PTTWE GMP4 Submittal Cover Page

ENGINEERING JUDGMENT FIRESTOP DETAIL

PROJECT : HJAIA PLANE TRAIN TUNNEL EXT. PH1
ADDRESS : 1300 WILLIAMS DR., MARIETTA, 30066

PLANE TRAIN TUNNEL WEST EXTENSION PHASE 1

Drawing No.
630917a

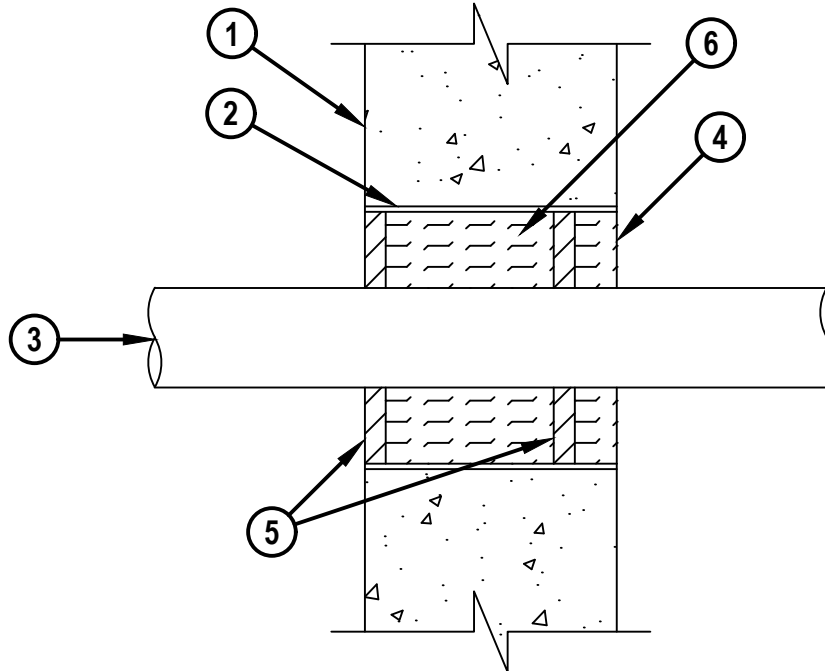
This EJ is to be applied at electrical conduits shown in the following pictures where there is adequate angular space between the conduit and sleeve for fire caulk and mineral wool to be installed around the entirety of the conduit.

Drawing No.
630957a

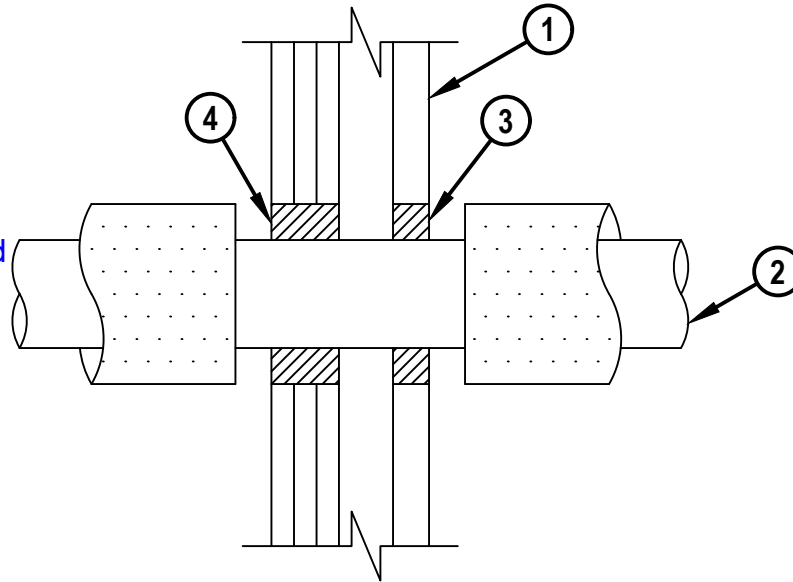
This EJ is to be applied at the (2) pump discharge pipes and the (1) fire standpipe. The (3) pipes referenced were not installed centered in the sleeve; therefore, there is not adequate angular space to install mineral wool & fire caulking around the entirety of the pipes. For this reason, we are proposing to build 3-hour shaft wall pump outs around the pipes and then applying fire caulk at the interface of the proposed shaft wall and pipe.

DATE:
04/02/2021
SCALE:
1/4" = 1'-0"
SHEET NO:
DP06 A 2.1.1

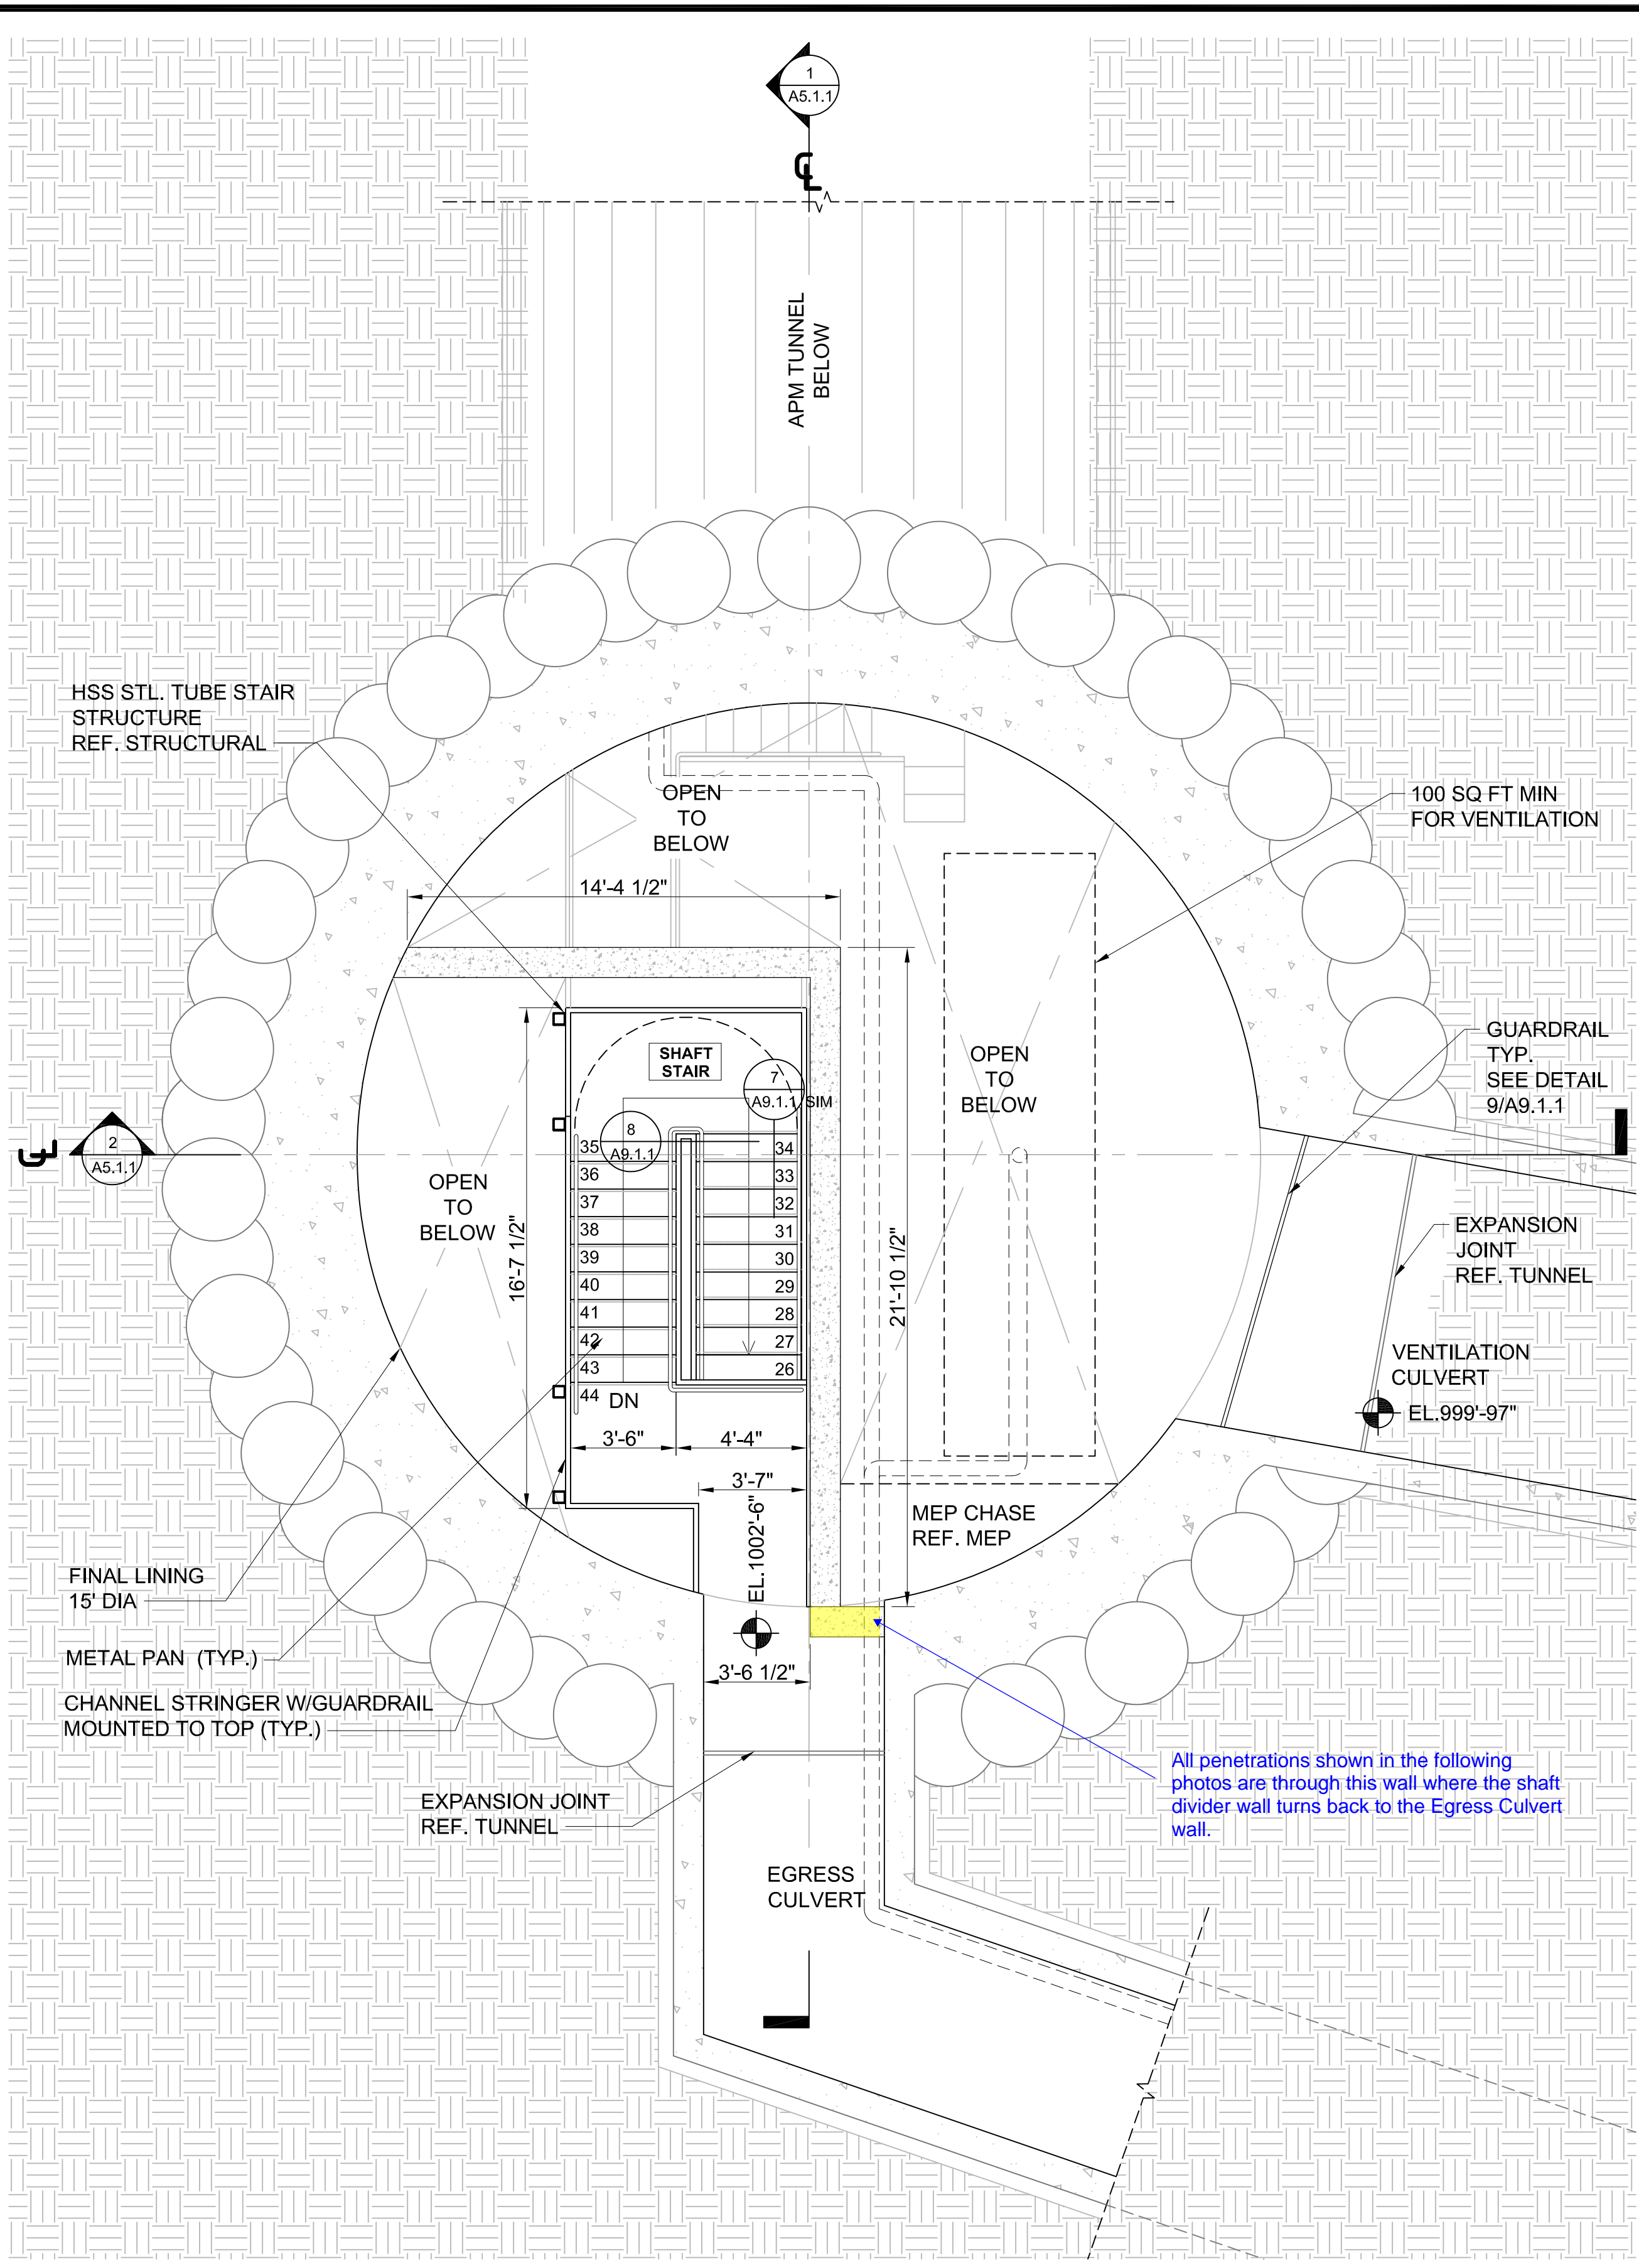
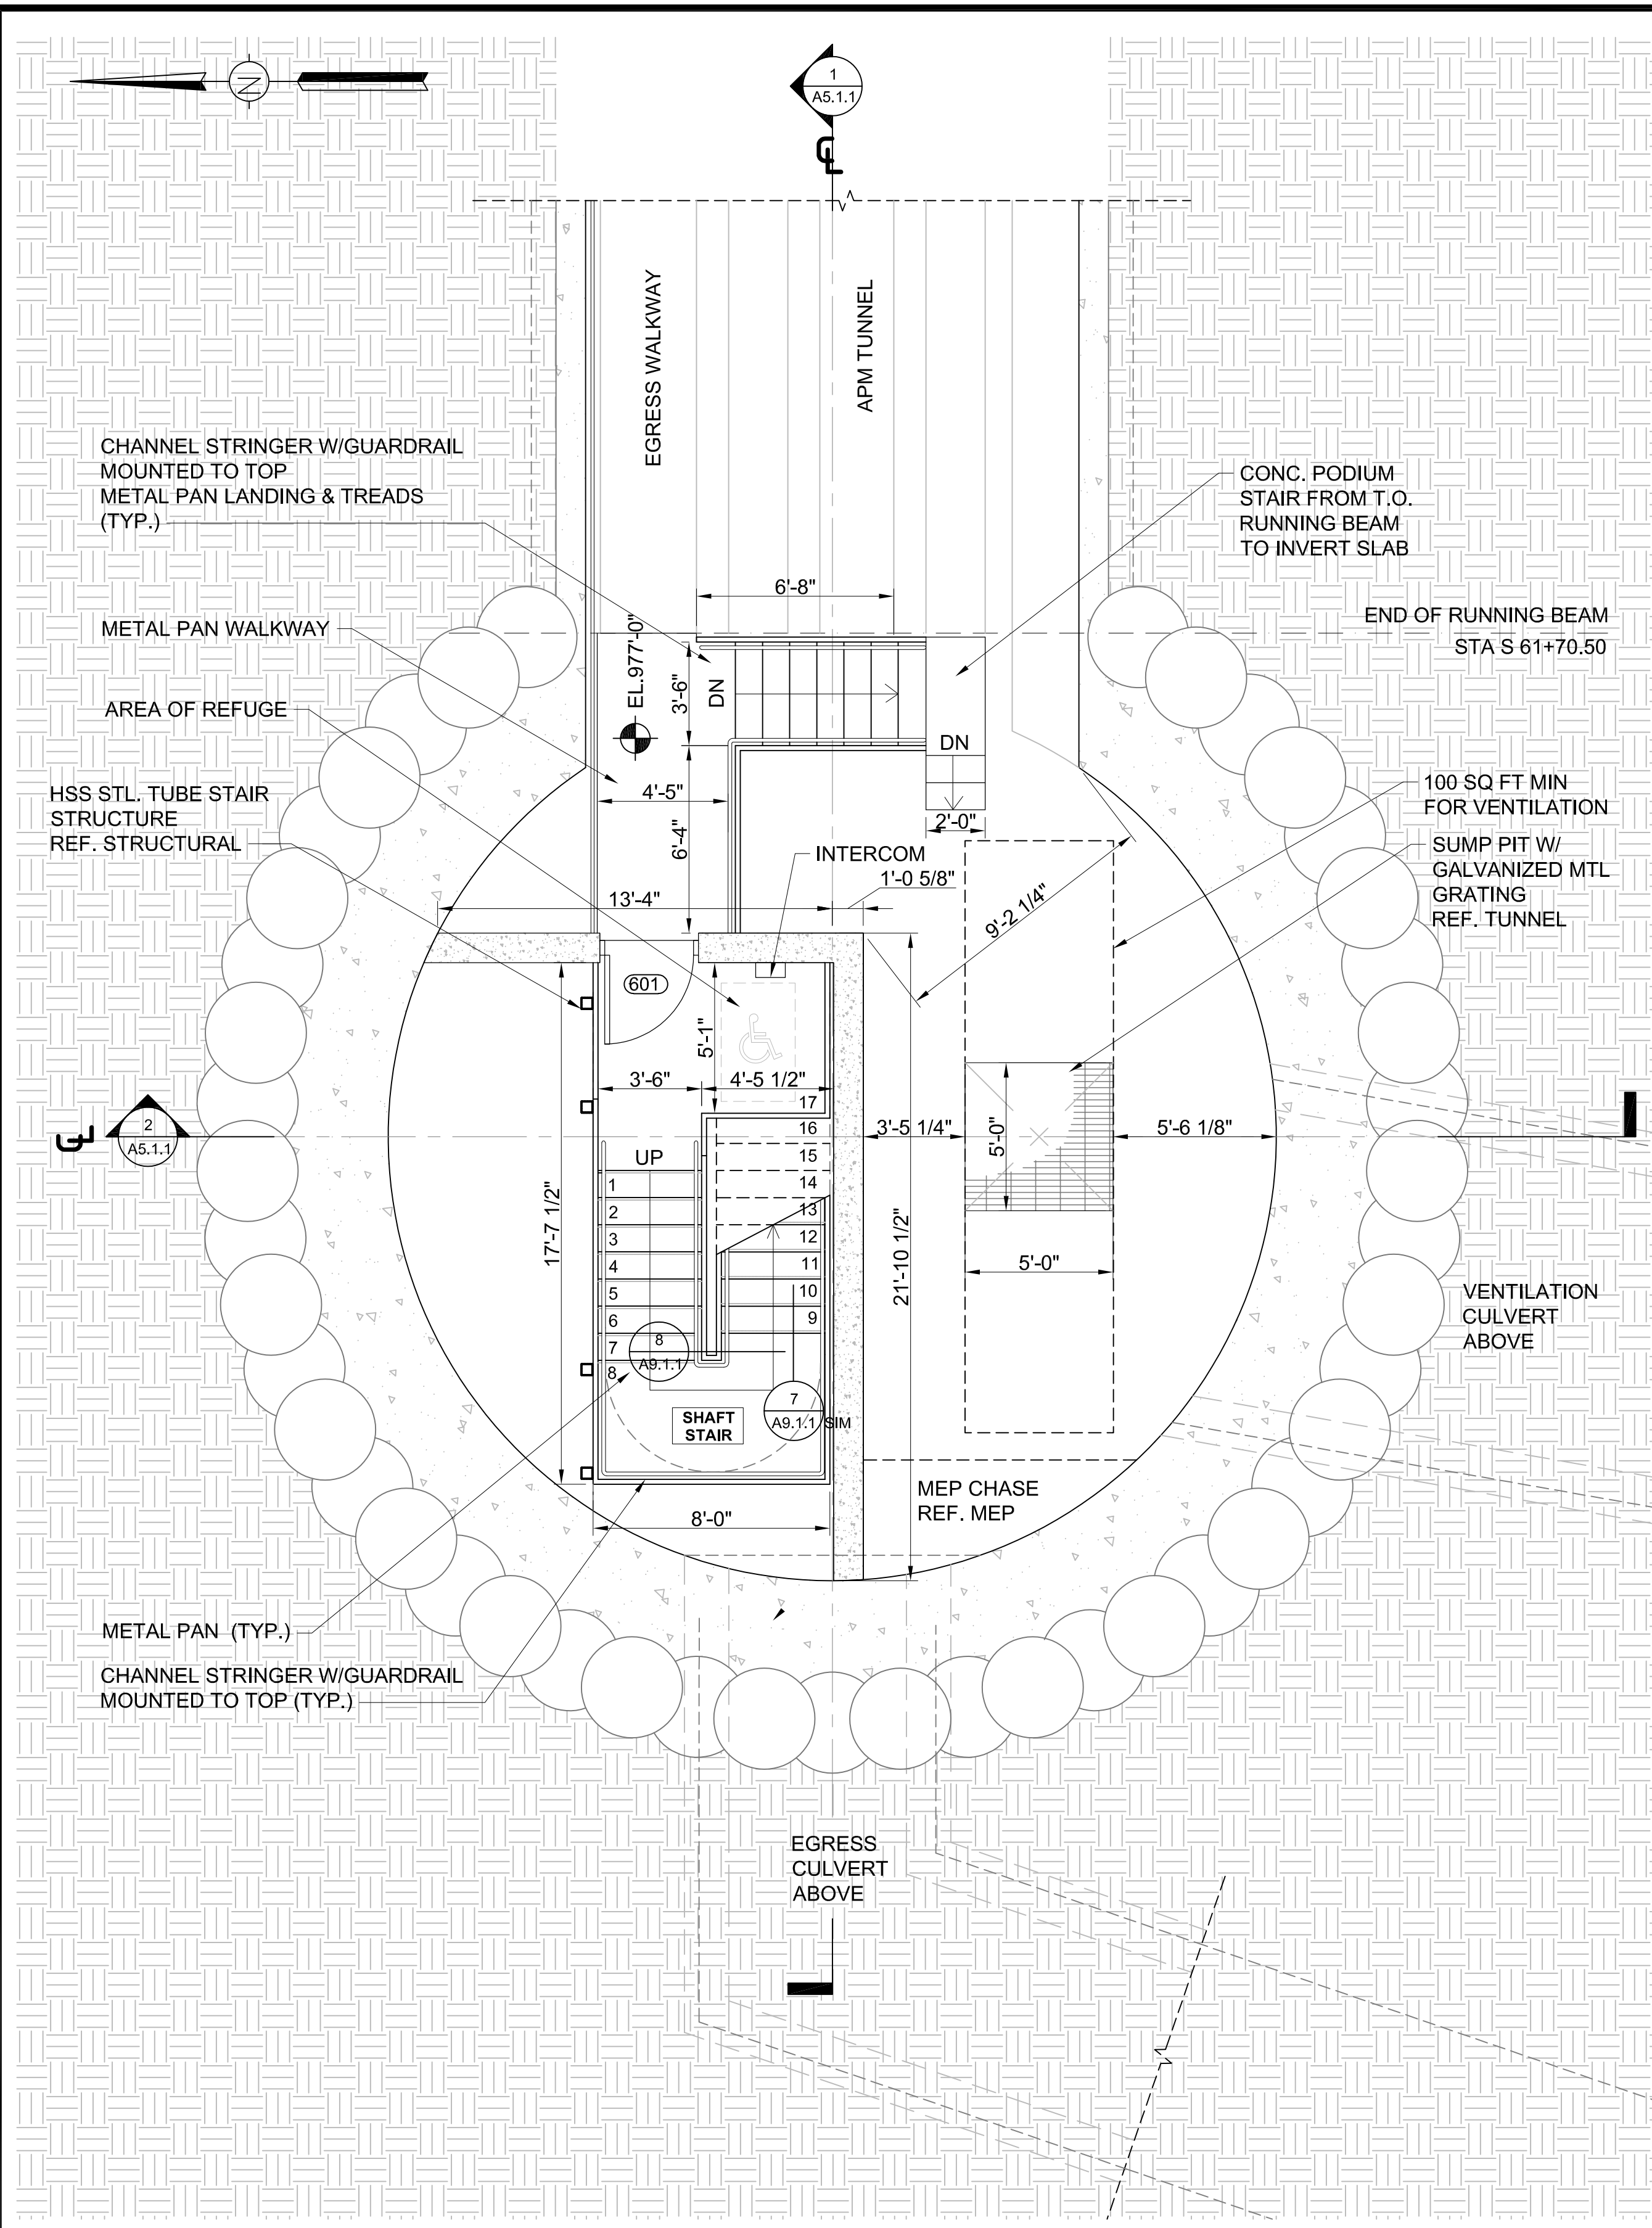
All penetrations shown in the following photos are through this wall where the shaft divider wall turns back to the Egress Culvert wall.

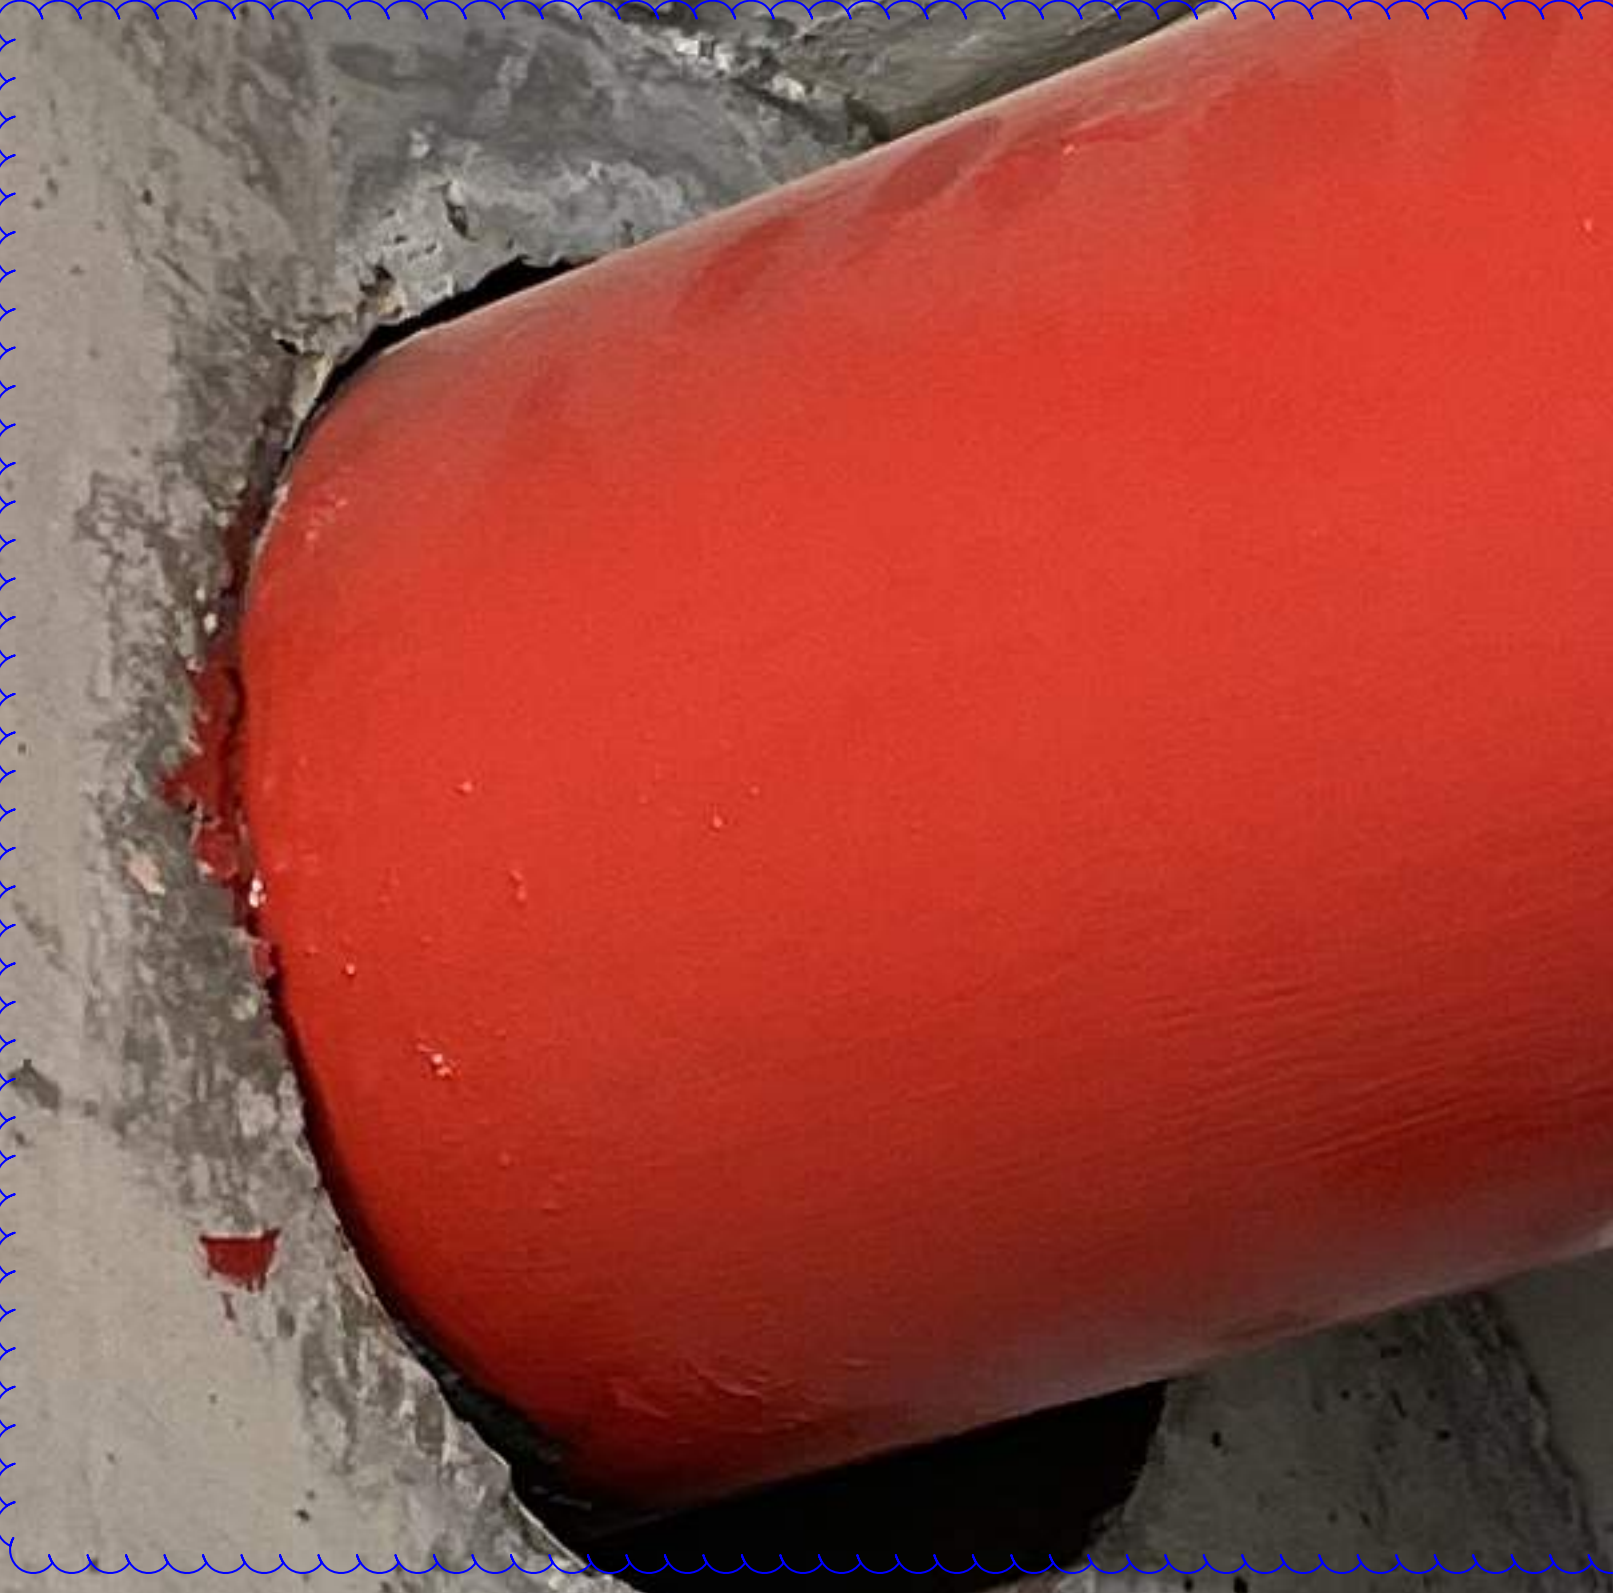
EJ 630917a to be applied at these penetrations

EJ 630957a to be applied at these penetrations

EJ 630957a to be applied at this penetrations

EJ 630917a to be applied at these penetrations

EJ 630917a to be applied at these penetrations

EJ 630957a to be applied at this penetrations
